City of Delray Beach
NE 2nd Avenue/Seacrest Beautification – Phase 2
Change Order 001

**CITY OF DELRAY BEACH
CHANGE ORDER TO ORIGINAL CONTRACT**

CHANGE ORDER NO. 1 PROJECT NO. 16-032 DATE: September 4, 2018

PROJECT TITLE: NE 2nd Ave. Seacrest Beautification Phase 2

SHEET: C-7

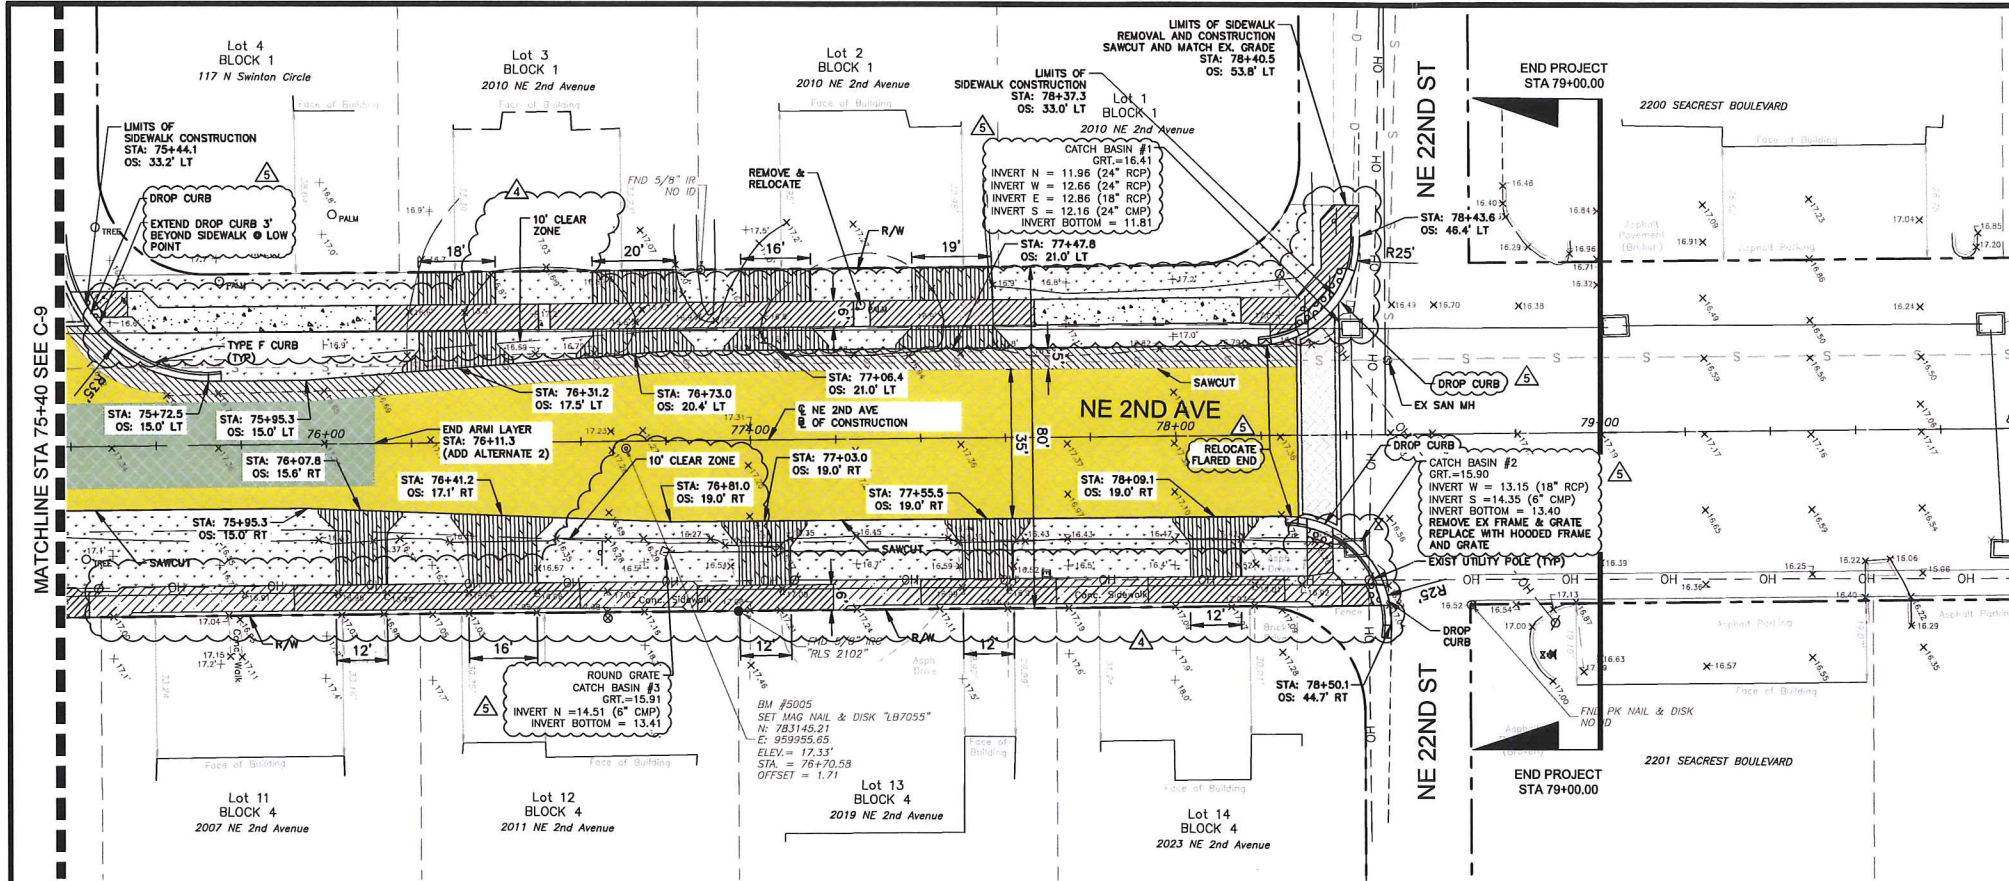
The above referenced Change Order No. 1 is for the additional costs and time impacts to extend the proposed Add Alternate 2 ARMI Layer to the areas not included as part of the Bid Contract Scope. As part of this Change Order Package we have enclosed a drawing identifying the additional locations, and we have included a letter from the Design Engineer of Record Wantman Group, stating that they do not object to this change in Contract Work Scope. The total costs for this additional Quantity of ARMI Layer will result in an increase to the Contract in the amount of \$107,565.00.

PROJECT	NE 2ND AVENUE / SEACREST PHASE 2
ENGINEER OF RECORD	BRETT OLDENDORF, P.E.
DATE	8/15/2018
CHECKED	BNO
DESIGNED	SCC
DRAWN	SCC
SCALE	1" = 20'
TITLE	ROADWAY IMPROVEMENT PLAN
SHEET:	C-6

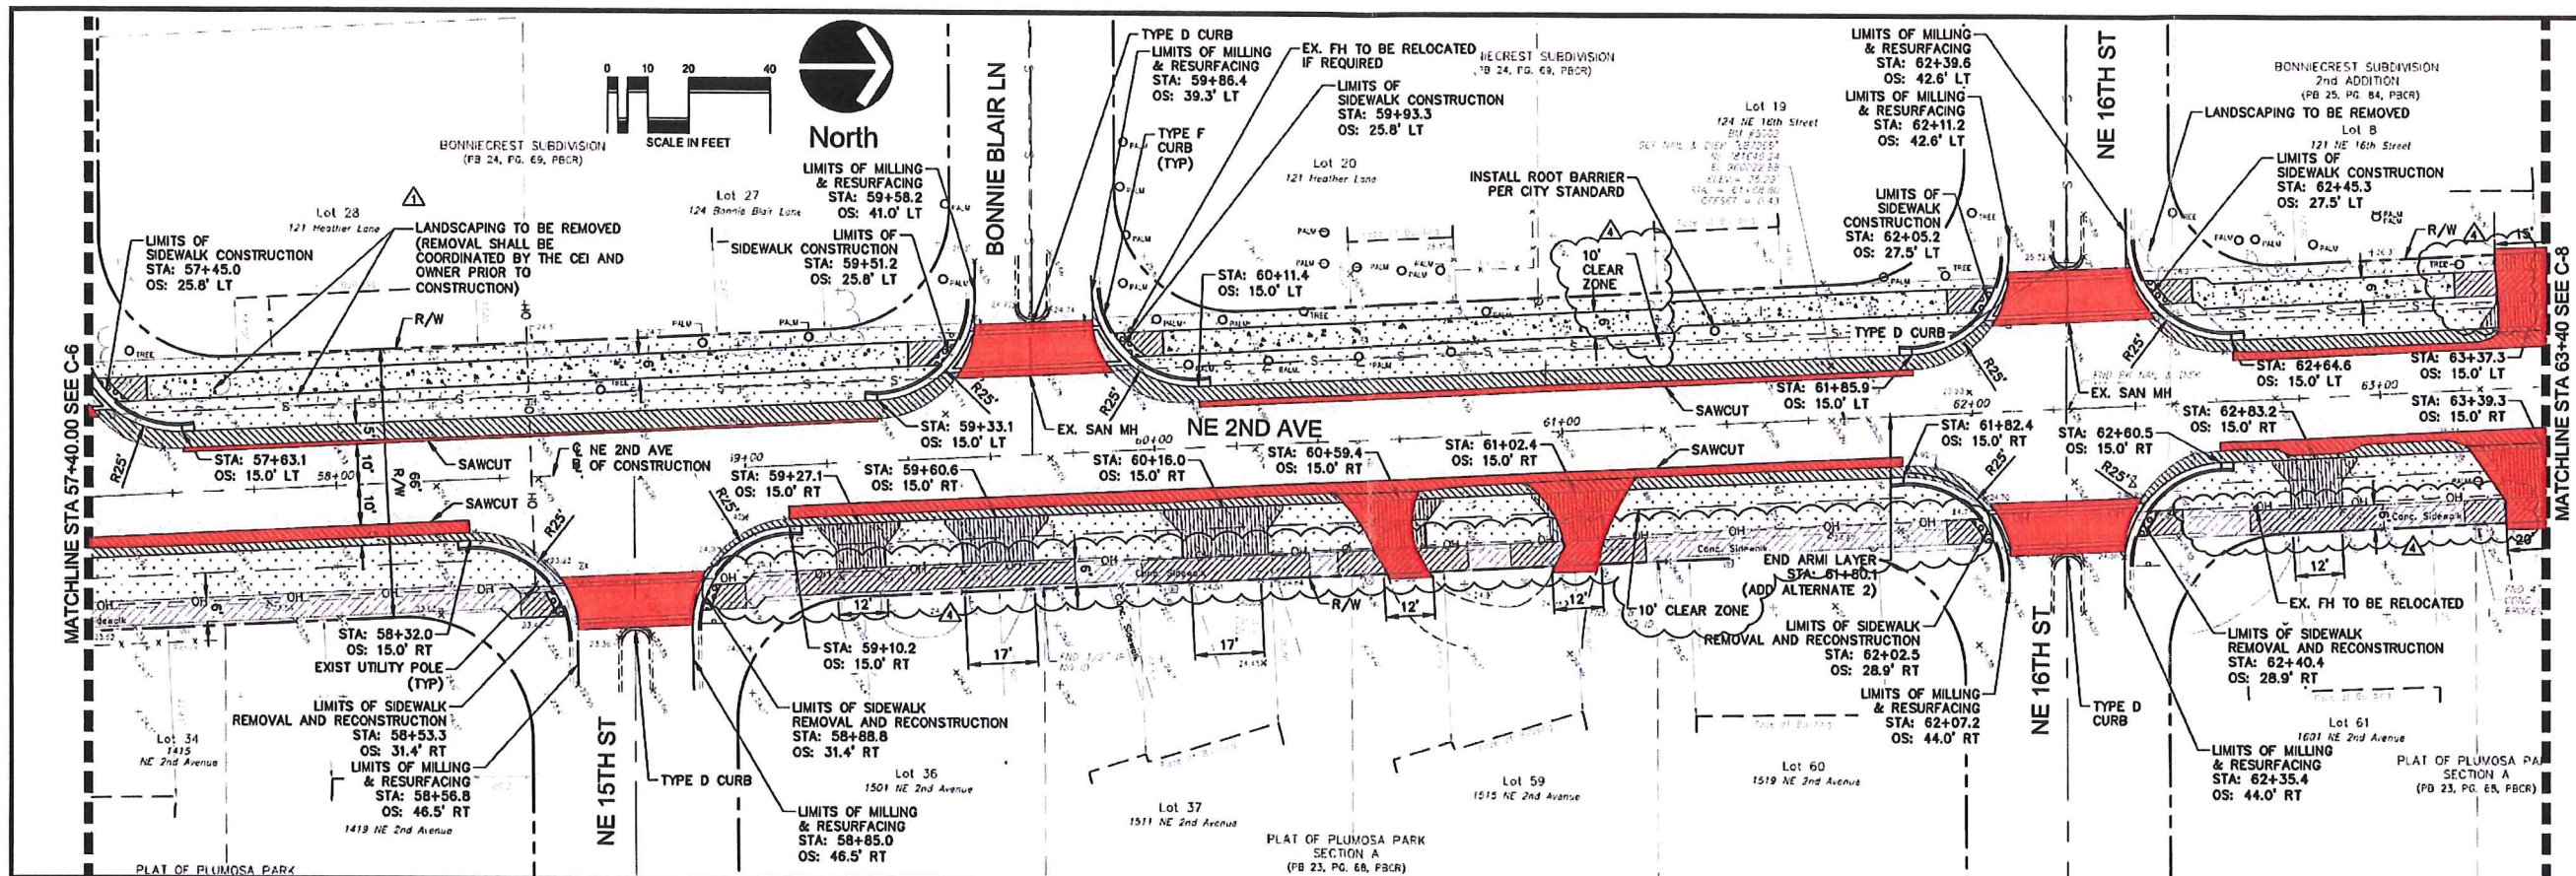
This Change Order also includes a quantity overrun projection for Pay Item #14 Pavement Removal. Our current total projection for this quantity is 2,601.20 square yards. The Bid Quantity Amount for this item is only 1,300 square yards. This results in a quantity overrun of 1,301.20 square yards. The total cost of this Quantity Overrun will result in an increase to the Contract in the amount of \$38,125.16.

Plan Sheet 6 4,798.2 SF
 7 4,529.9
 8 5,081.2
 9 8,804.8
 10 6,510.1
 Total ASPH Removal 29,724.2
 = 3,302.7 SY

SHEET: C-7

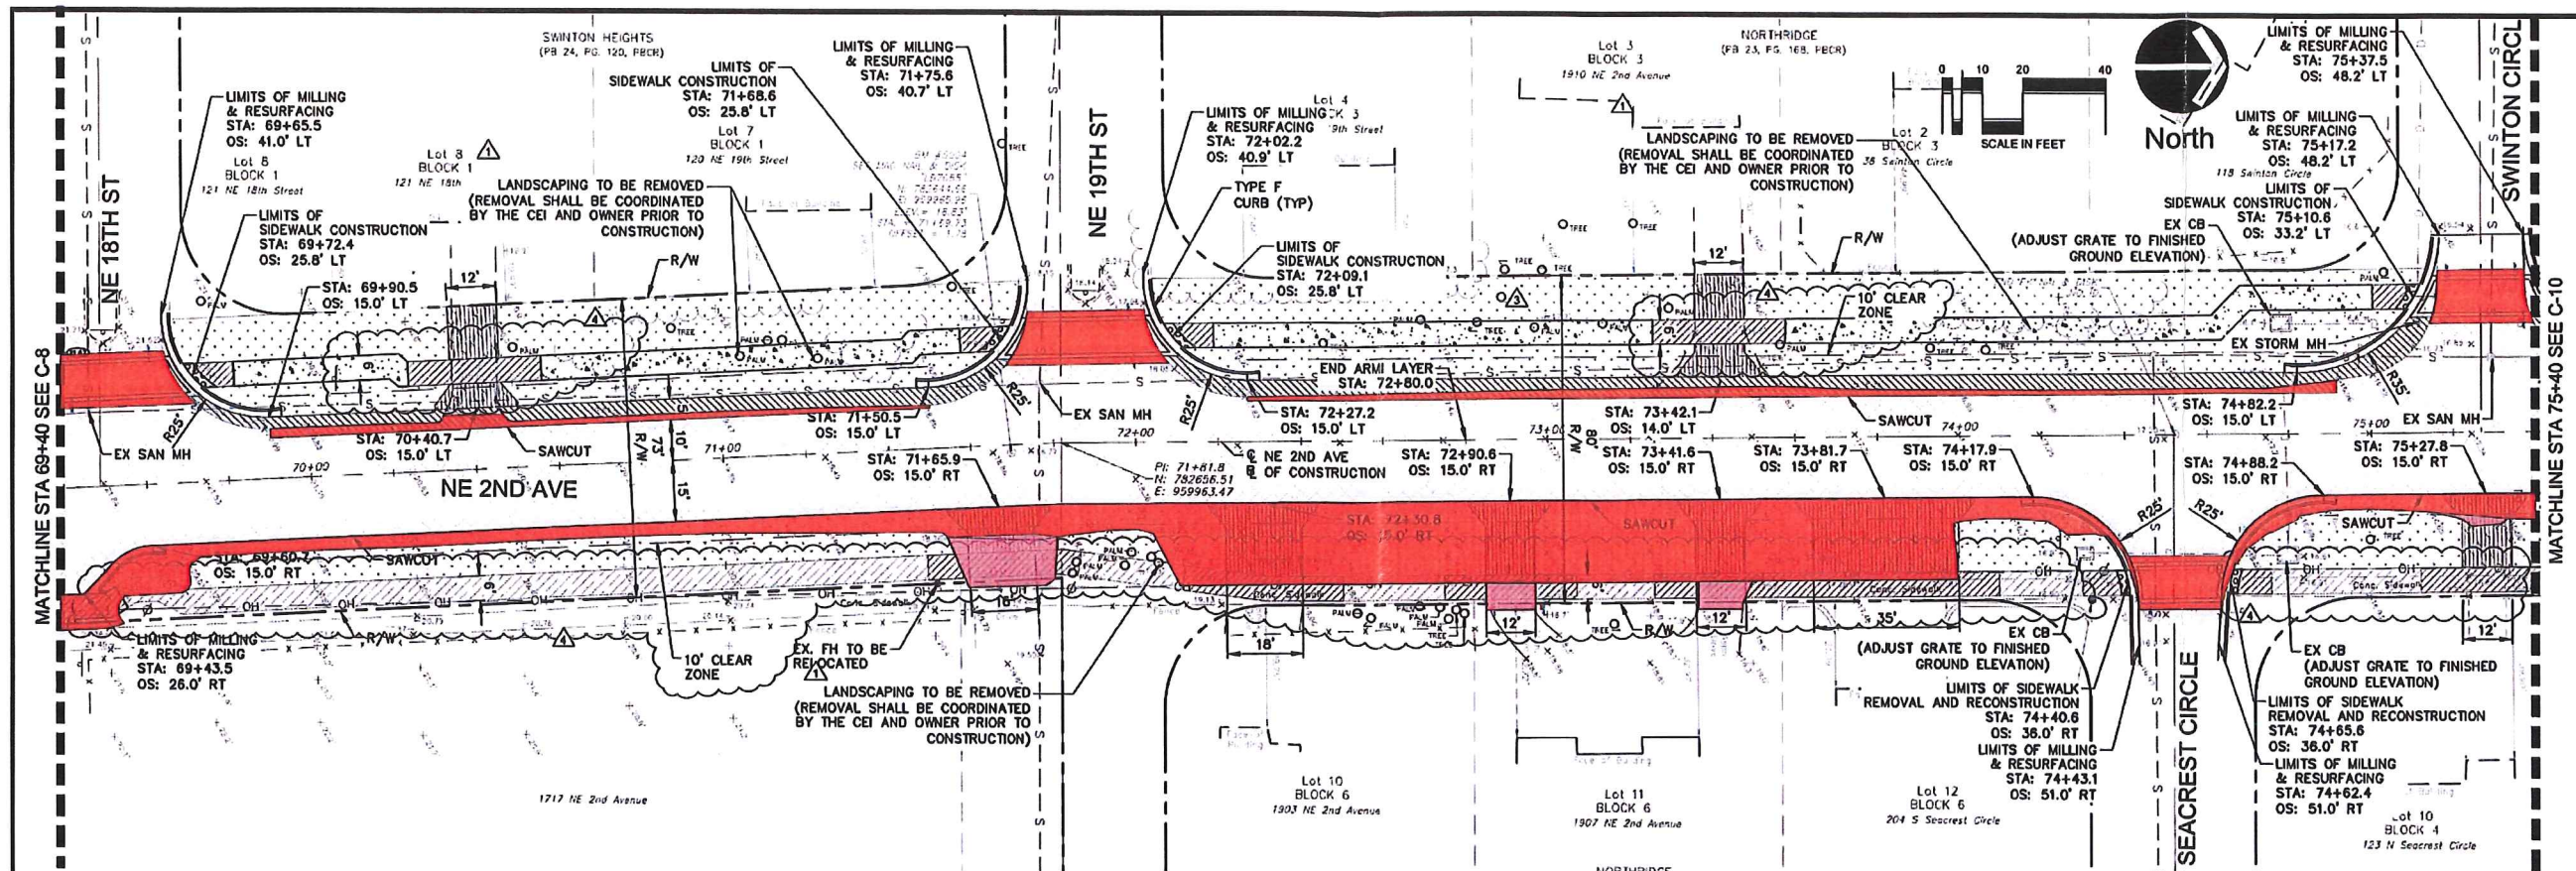
Asphalt Removal **4529.9 SQ FT**

SHEET:
C-9

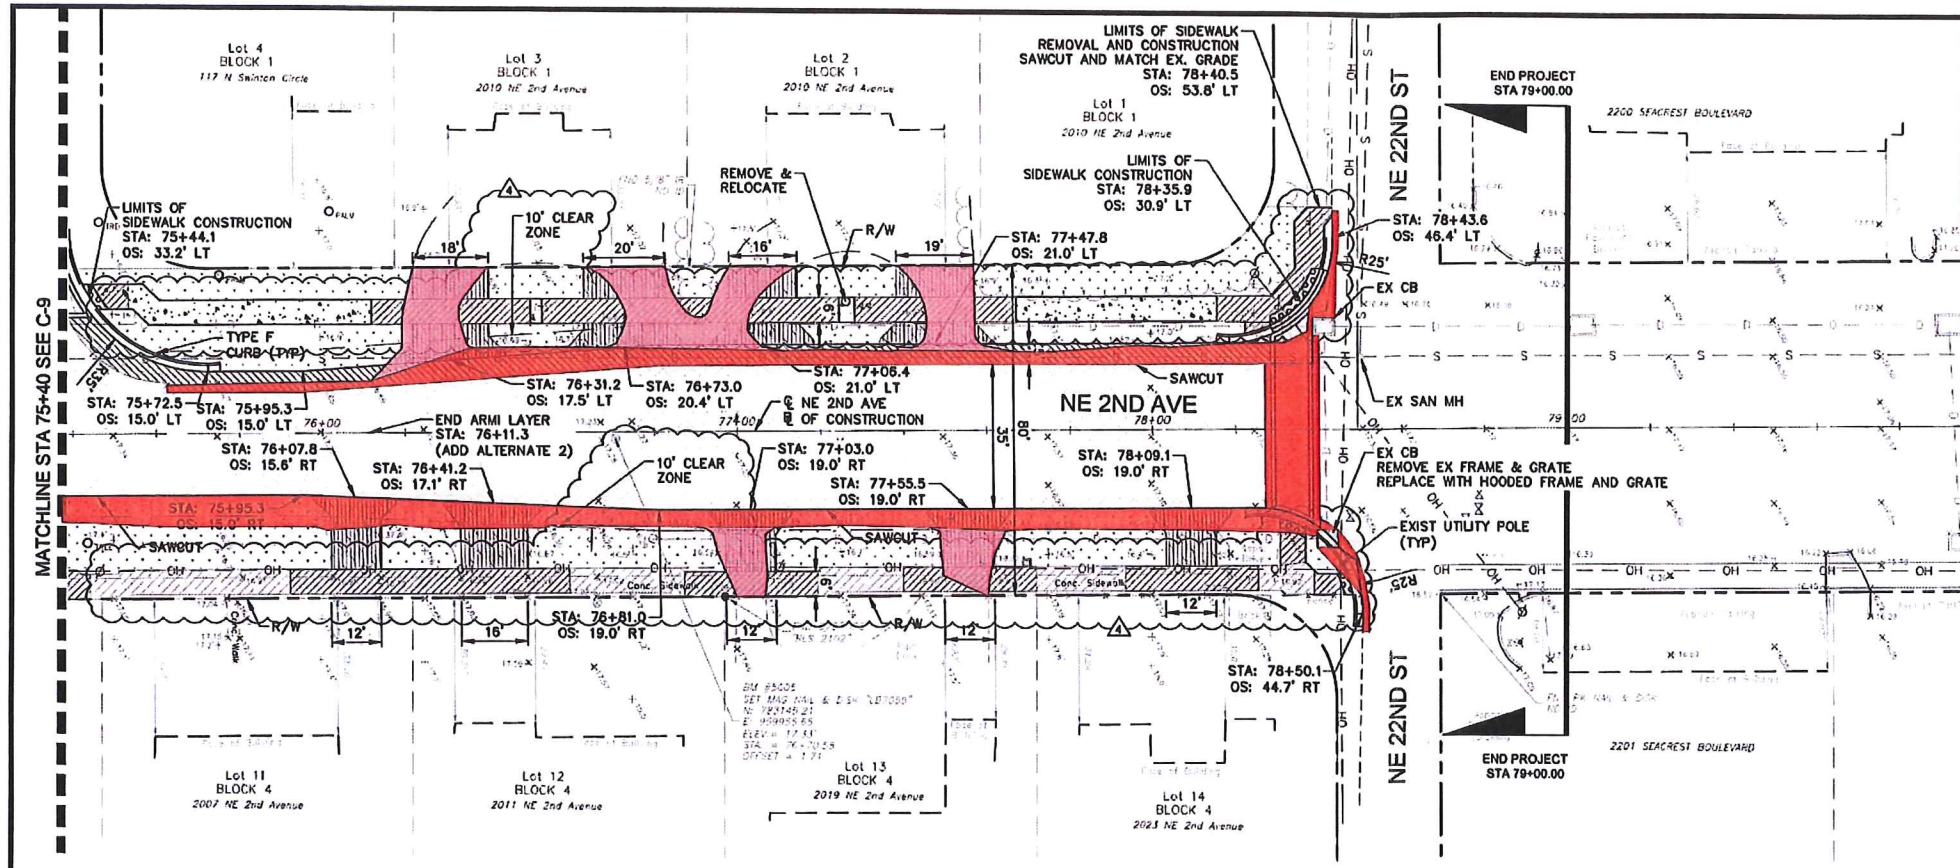
Asphalt Removal	8328.4 SQ FT
Asphalt Driveway R...	476.4 SQ FT
